FROM: HP Microwave Division

**INSTRUMENTS:** HP Model 8690A - Sweep Oscillators  
Serials Below Prefix 641-00261

**SUBJECT:** Oscillations in + 275 Volt Supply

Figure 1. A6 Assembly After Modification

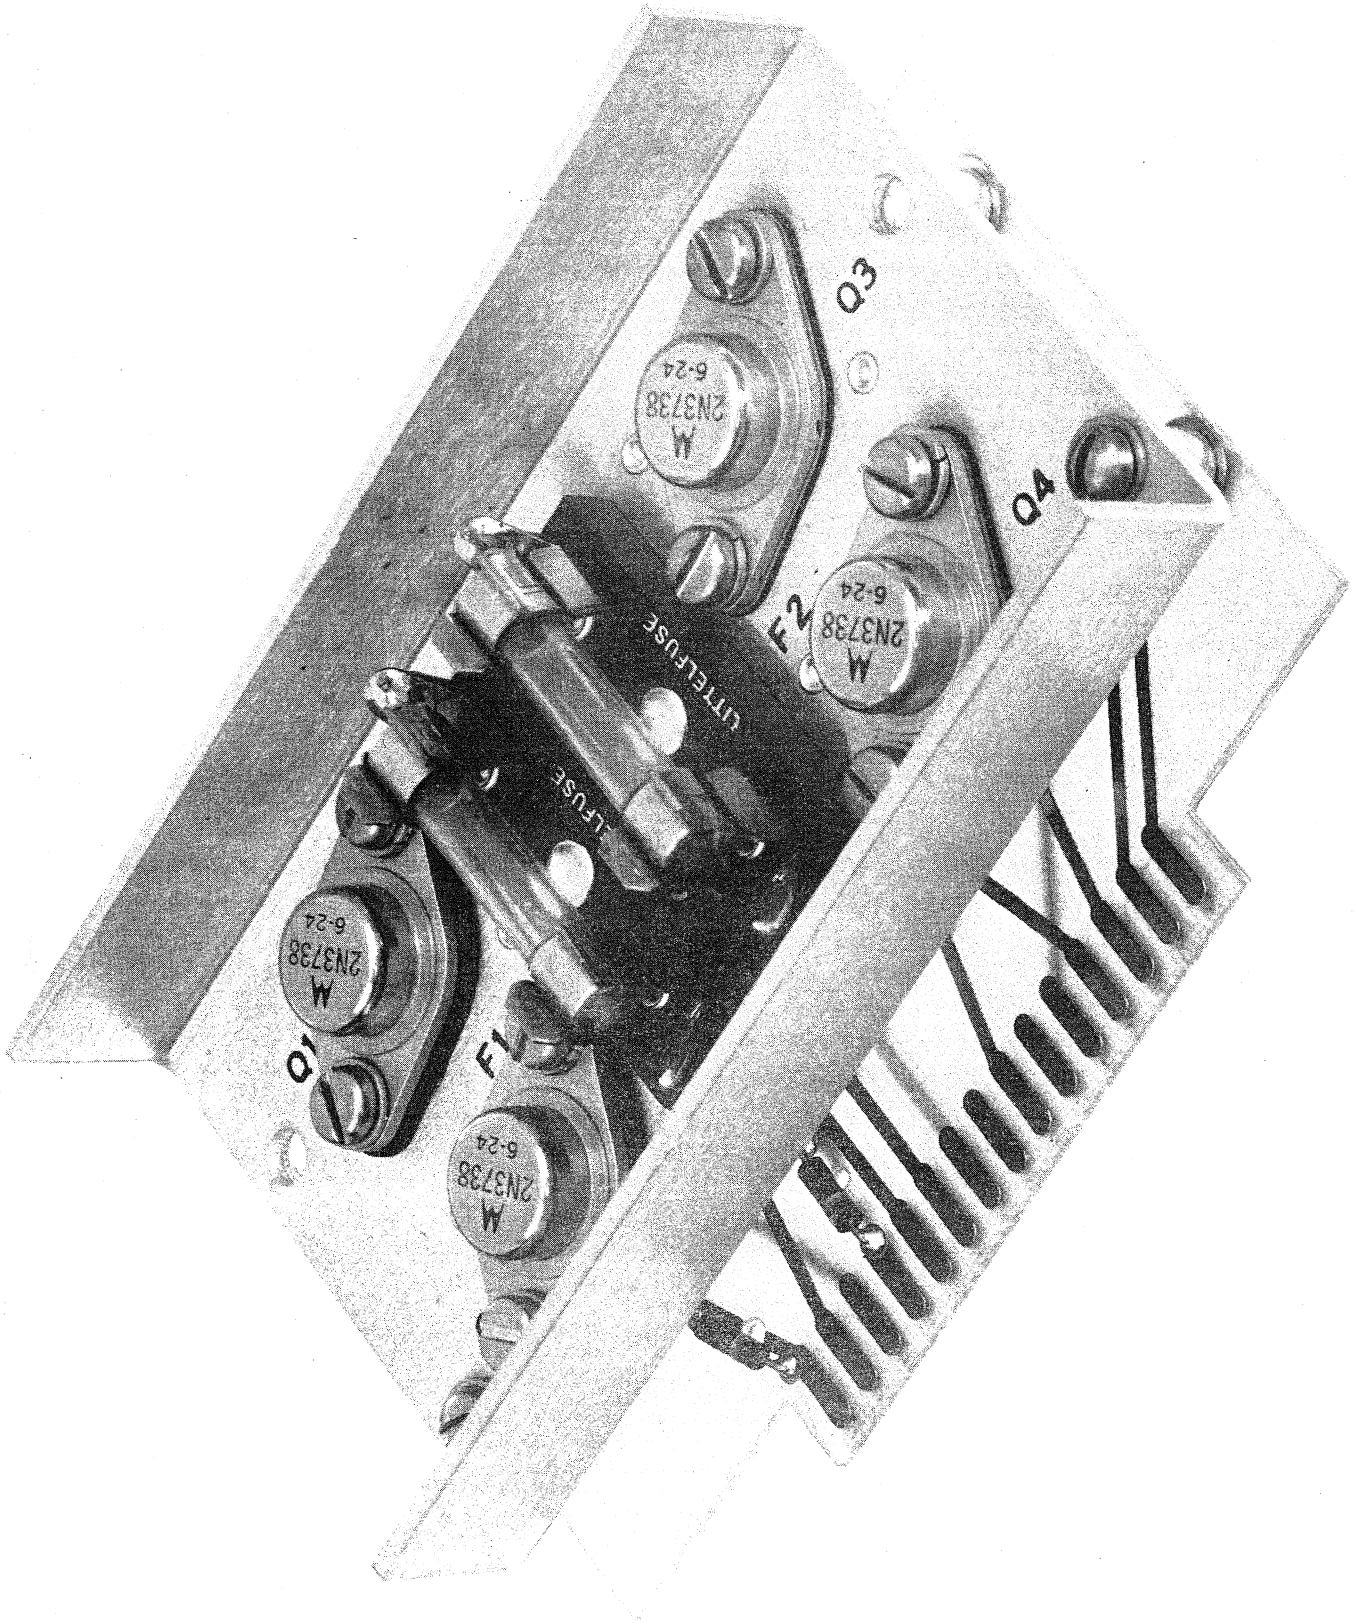
Some 8690A's have had 10 MHz oscillations in the + 275 volt power supply. The problem is caused by parasitic oscillations in A6Q1 and A6Q2. The fix is to add a 100 ohm  $\pm 10\%$ , 1/4 watt resistor, HP Part Number 0684-1011, in series with the base of each transistor.

To do this you have to modify the A6 regulator board assembly, HP Part Number 08690-6024 as shown in Figure 1. The board can be modified without disassembling.

The 100 ohm resistors are connected between PIN 12 on A6 and the base of A6Q1 and between PIN 15 and the base of A6Q2.

The conductor between the PINs and the bases of the transistor can be opened by drilling through the foil. Also, two mounting holes must be drilled for each resistor.

All the drilling can be done from the soldered side of the board. Note that the resistors are mounted on the other side of the board as close to PINs 12 and 15 as possible.
